Re: PETITION TO INITIATE SPECIAL INVESTIGATION
ON SIGNIFICANT AP1000 DESIGN DEFECT

Post Accident AP1000 Containment Leakage

An Unreviewed Safety Issue

A Report by Arnold Gundersen, March 26, 2010
Chief Engineer, Fairewinds Associates, Inc

- Figure 1 – AP1000 in normal operation.
- Figure 2 – AP1000 design basis accident begins.
- Figure 3 – AP1000 containment hole opens as containment fills with radioactive gases.
- Figure 4 – AP1000 chimney effect draws radioactivity directly into the environment.

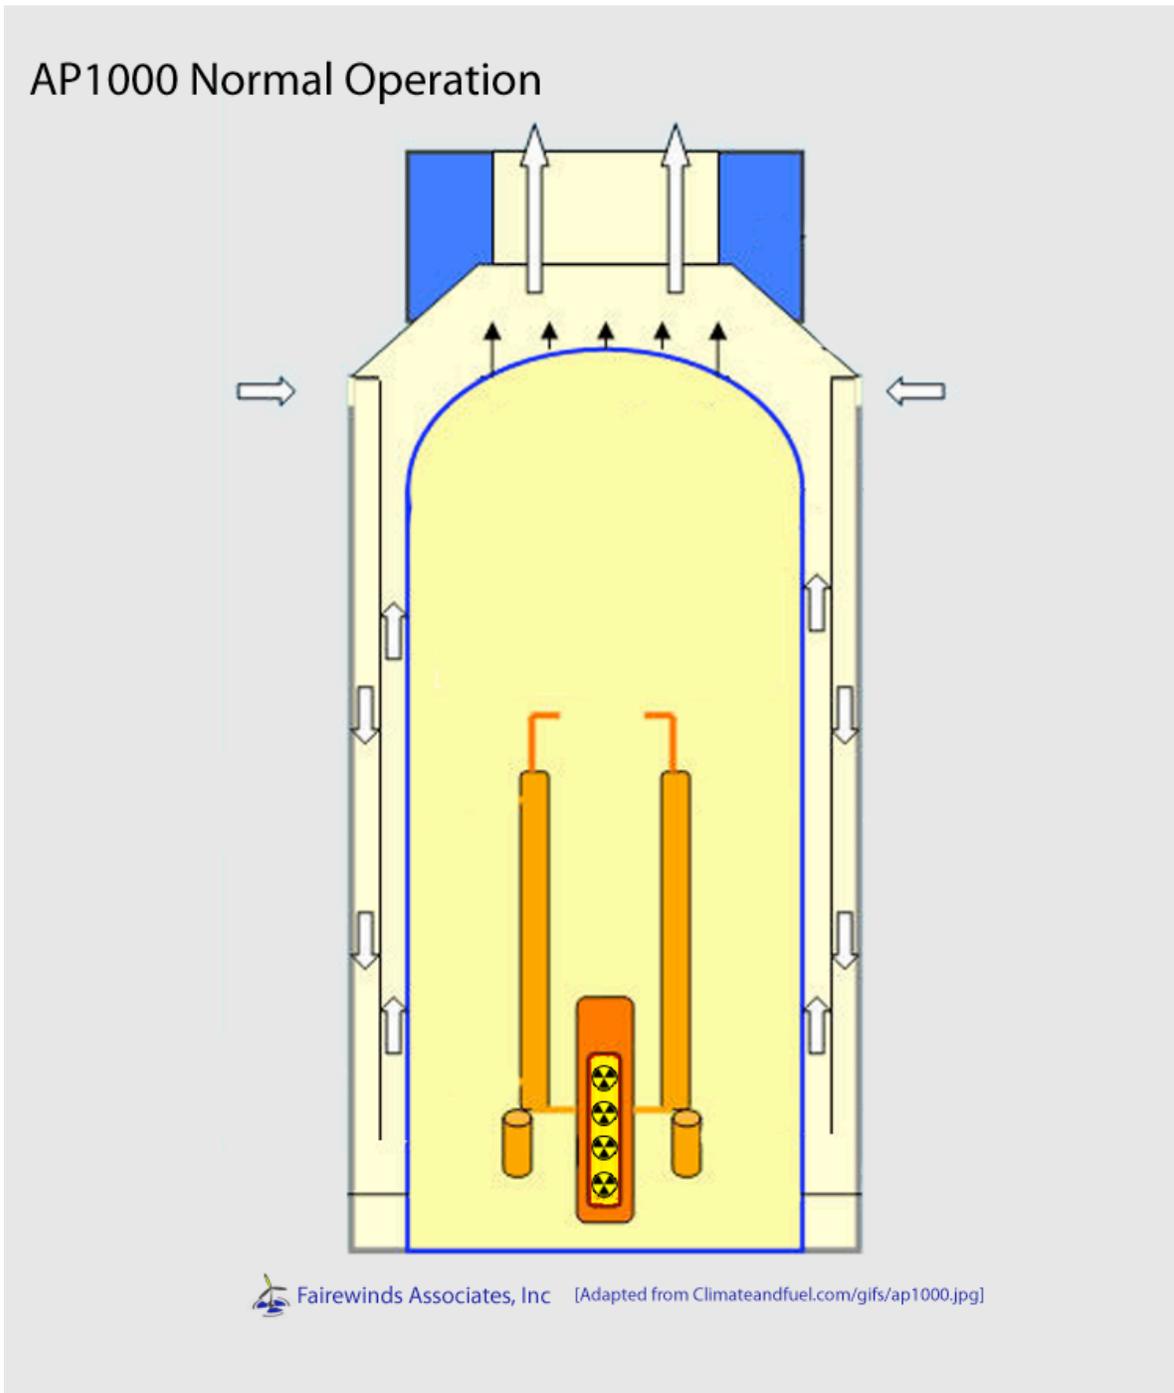
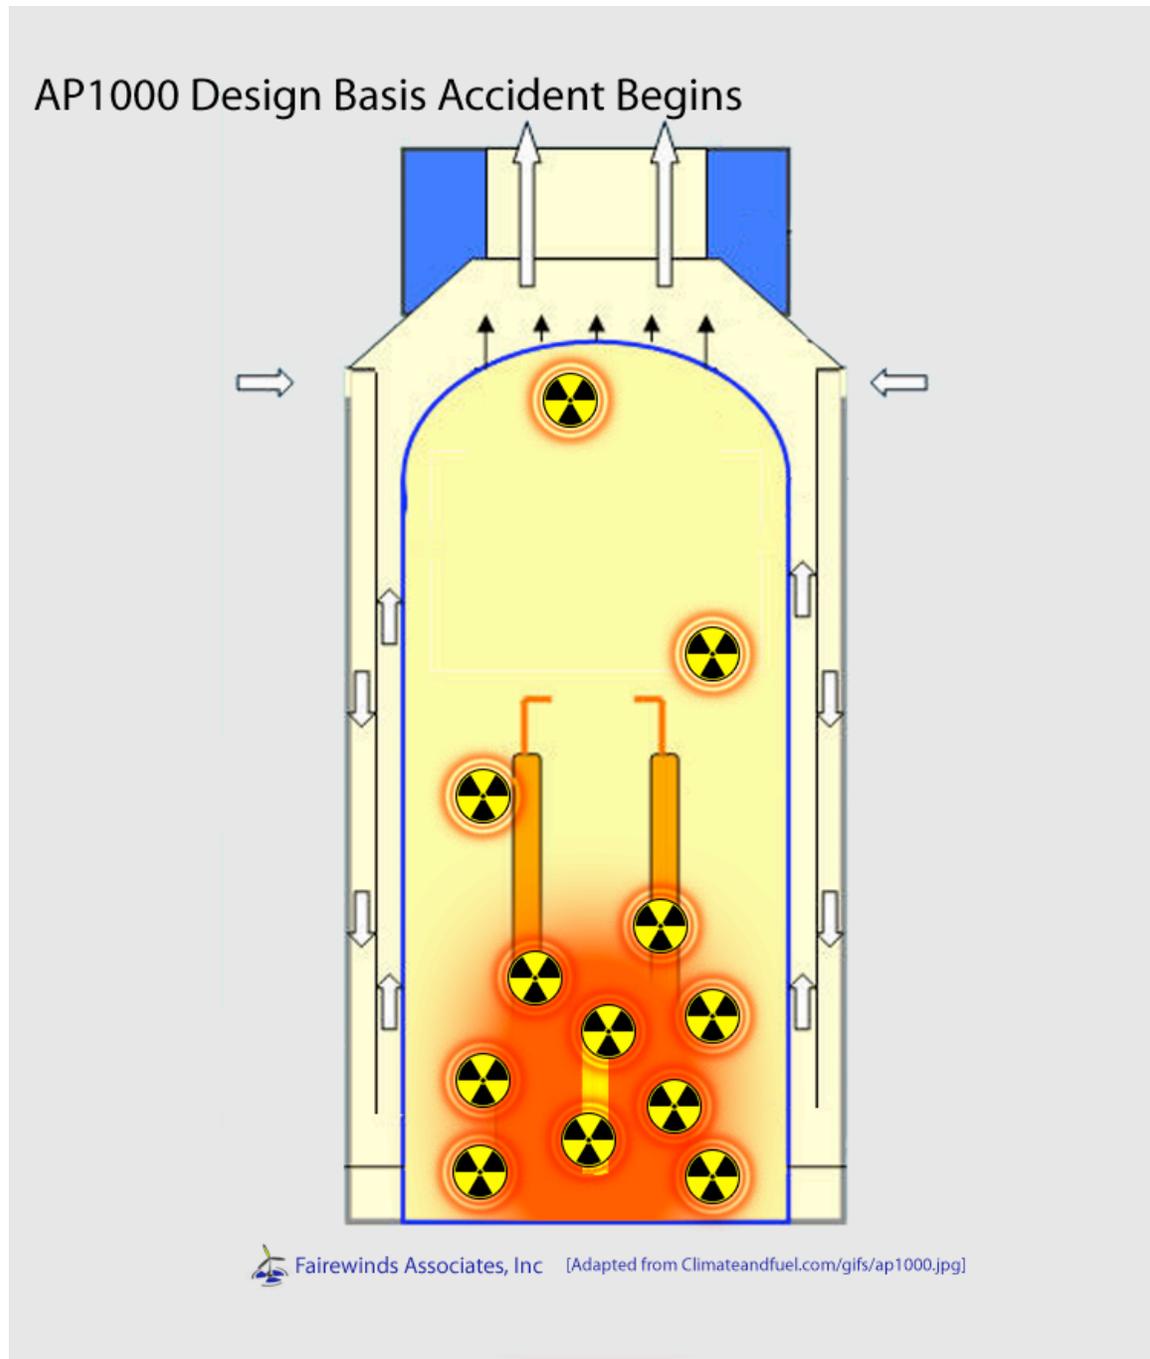
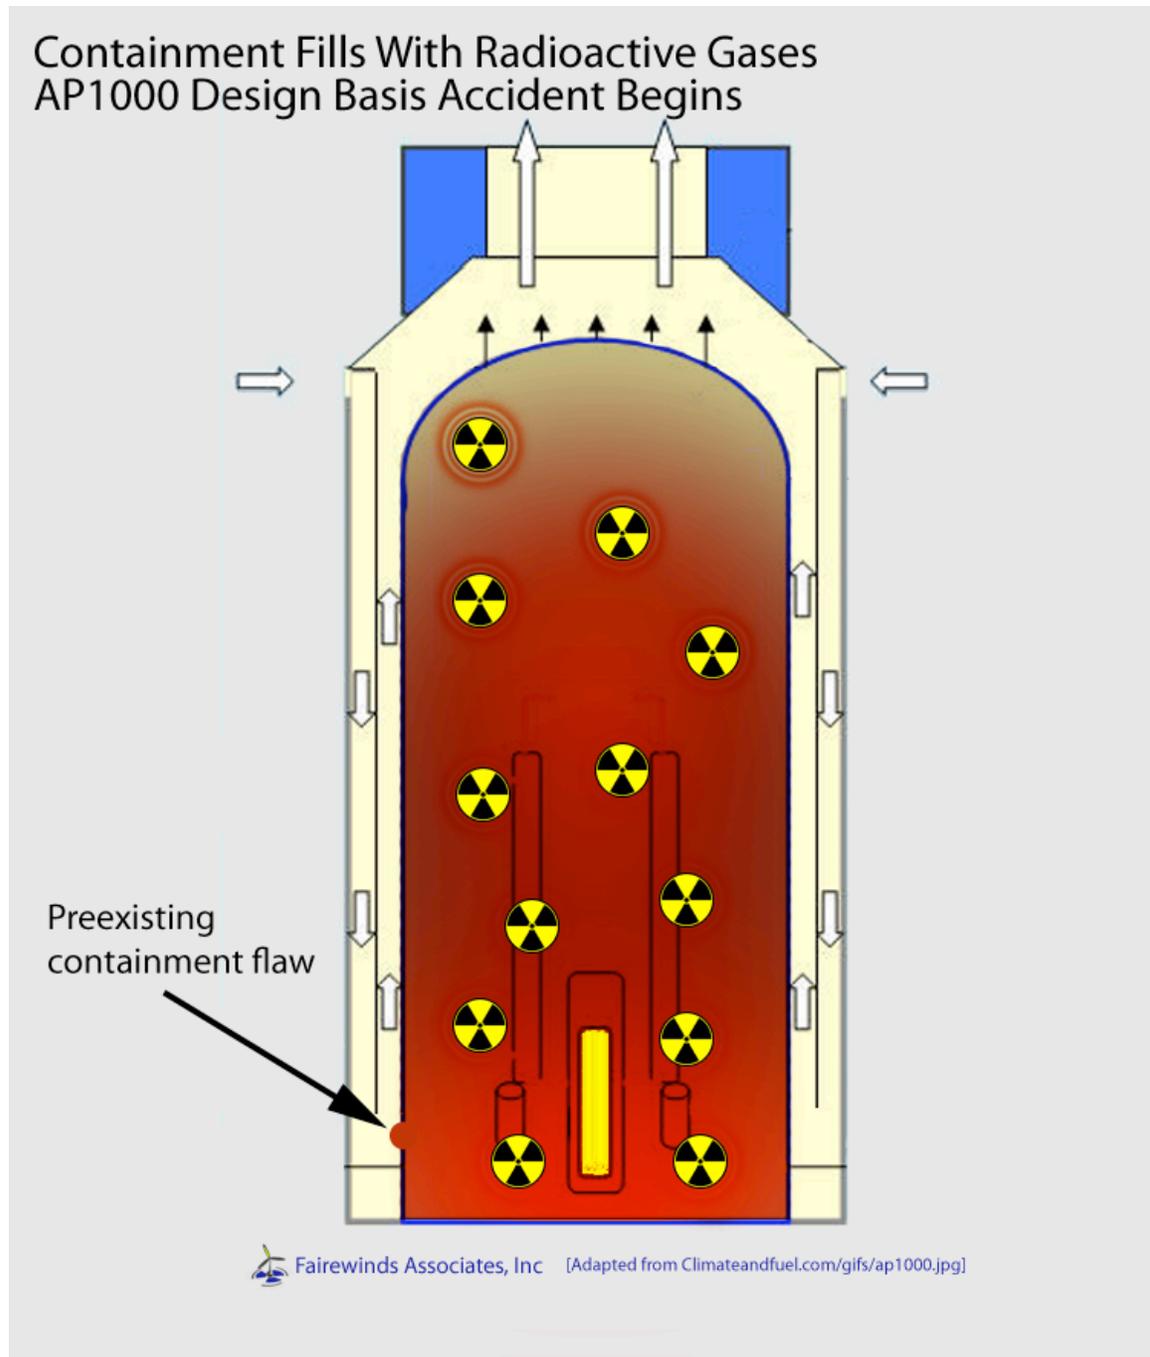
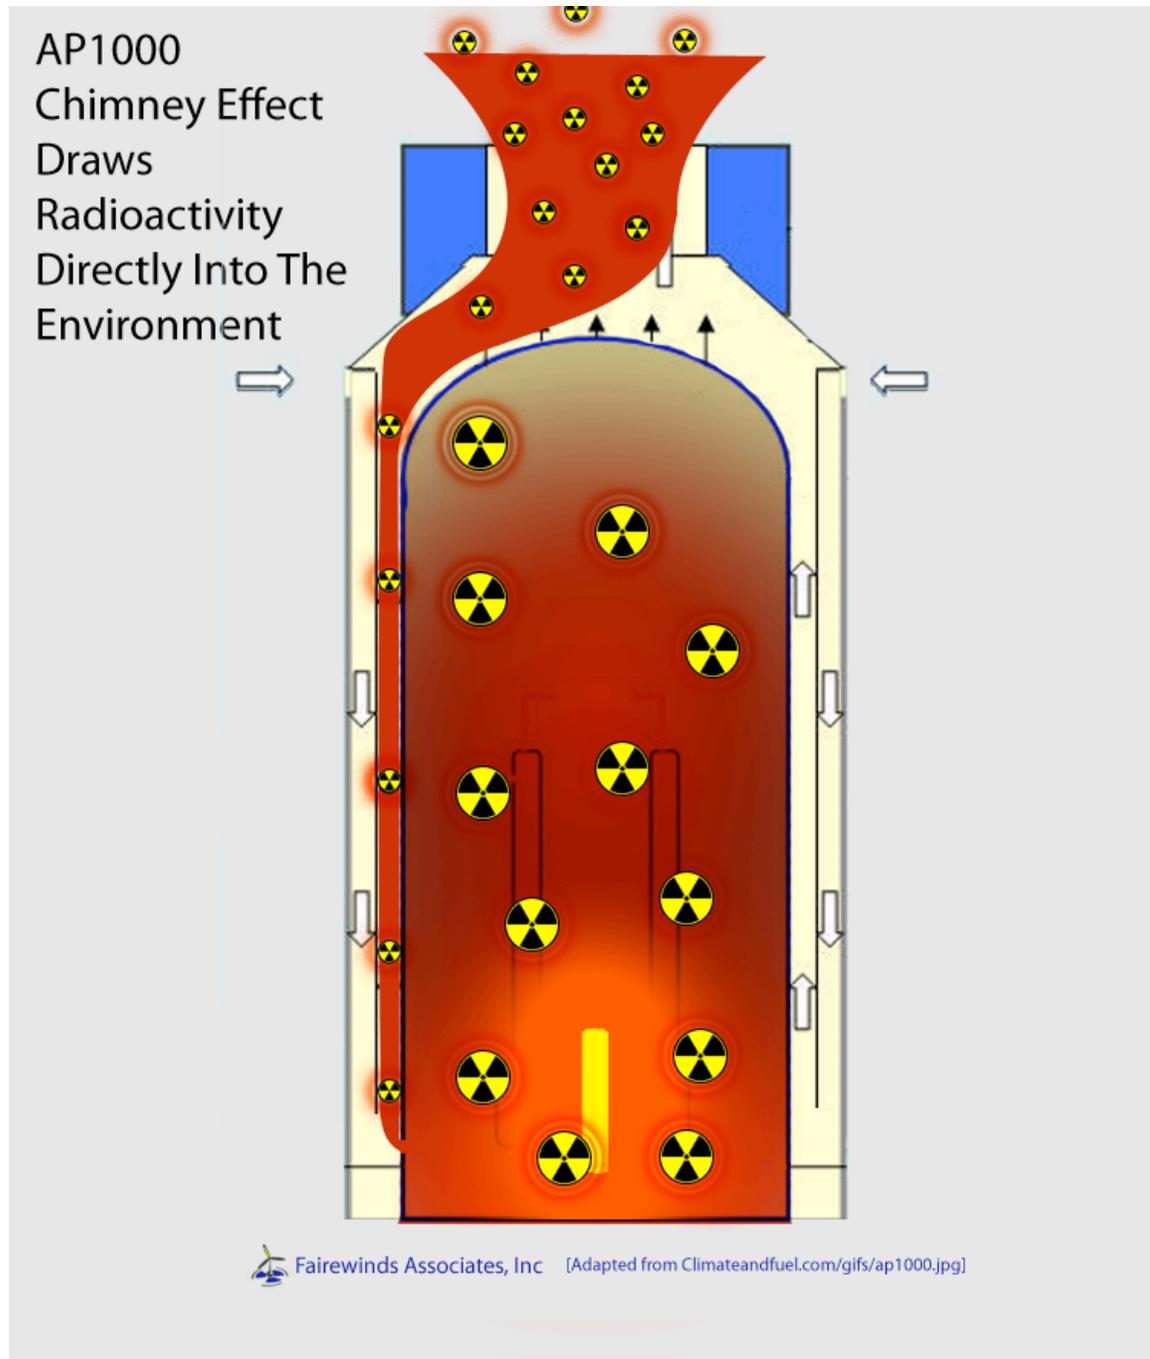
Concernedly, the hybrid AP1000 containment system appears to lack any of the redundancy or defense in depth²¹ in containment system design that was present in earlier designs reviewed in this report and upon which *design bases events* are predicated.
